Summary Statement

1. Unresolved Technical Issues

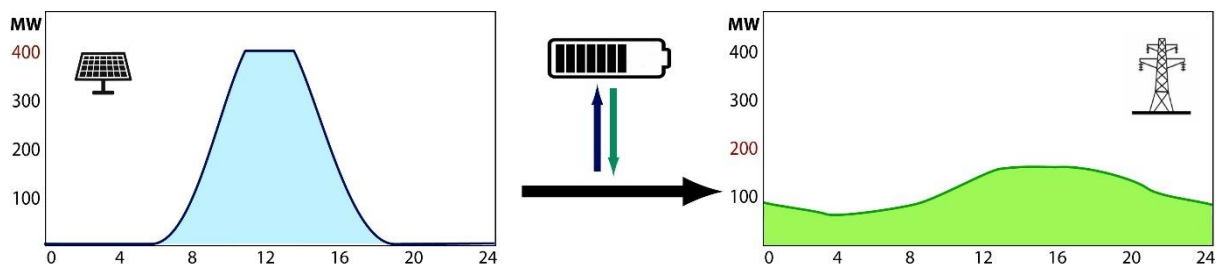
The battery allows energy generated in the middle of the day to be exported when required. Thus, it can convert the PV generation profile to match the grid's Demand profile.

1) A battery reduces a farm's required export power rating by over 50% for the same amount of energy (diagram above). This translates into reduced cost of the transformers, switchgear and grid corridor. Most significantly, the NG contract capacity can be halved. Grid capacity is identified as the limiting technical constraint for the Net Zero grid.

1.2.2 Remote battery

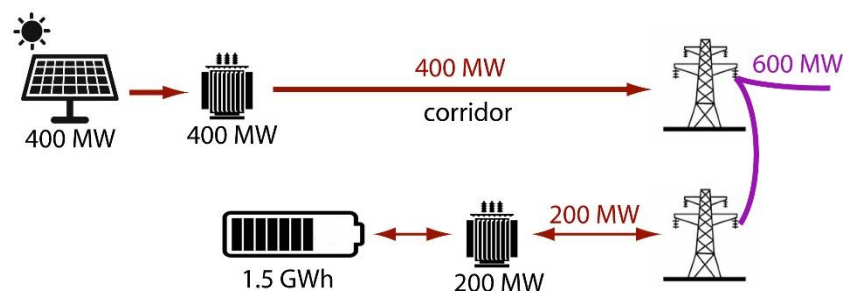
The location of a remote battery – a field adjacent to the solar farm, near a substation or distributed across multiple grid-connected facilities – does not affect the analysis.

In this configuration the transformer/switchgear in the PV pathway must handle 400 MW, as must the corridor cabling. An additional transformer is required for the battery facility. Grid capacity is increased threefold, as the infrastructure has to be able to support simultaneous maximum export from both sources.

Losses are introduced into the PV-to-battery pathway. As well as transmission line losses, transformers have <99% efficiency. There are at least five transformer stages in this pathway, based on the Applicant's proposal (LV→33kV→132kV→400kV→33kV→LV).

Moreover, unless the solar farm operator also owns the battery, there is no guarantee that all surplus solar production will be sold. Battery facility operators purchase electricity as and when the hourly wholesale price is most attractive.

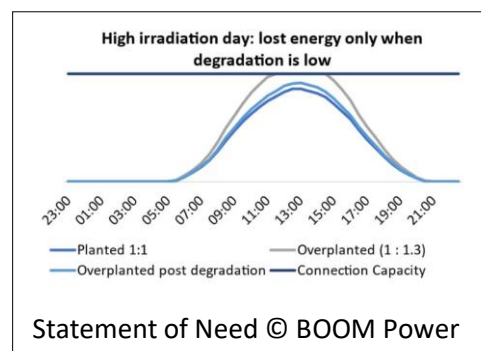
The Applicant explains how overplanting results in clipping within inverters to cap the output power when panel degradation is still low [Need, 6.6].

The ratio is better described as DC/AC ratio, as clipping depends specifically on the ratio of the maximum power offered at the DC input of the inverter to its rated (maximum) AC output.

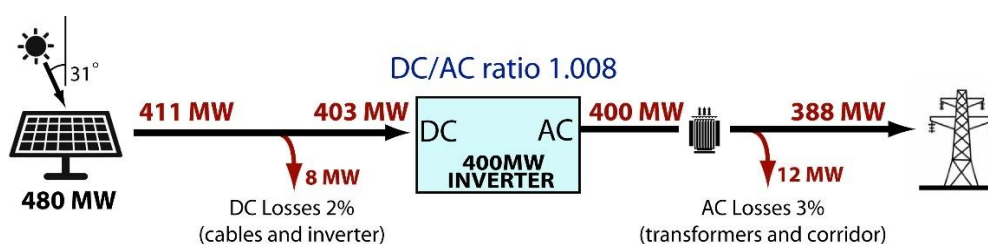
For a domestic installation with a south-facing roof, the distinction is moot. For larger solar farms, the complete system must be considered.

For SAT-configured panels, peak output from 480 MW(p) will be 411 MW for 31° off-axis direct illumination ($480\cos(31)$). DC and AC losses are estimated at 2 and 3% respectively.¹¹ For a 400 MW inverter the DC/AC ratio will be 1.008 with an export capacity of 388 MW.

Typical panels degrade by 1% in the first year, so clipping will have ceased by then.
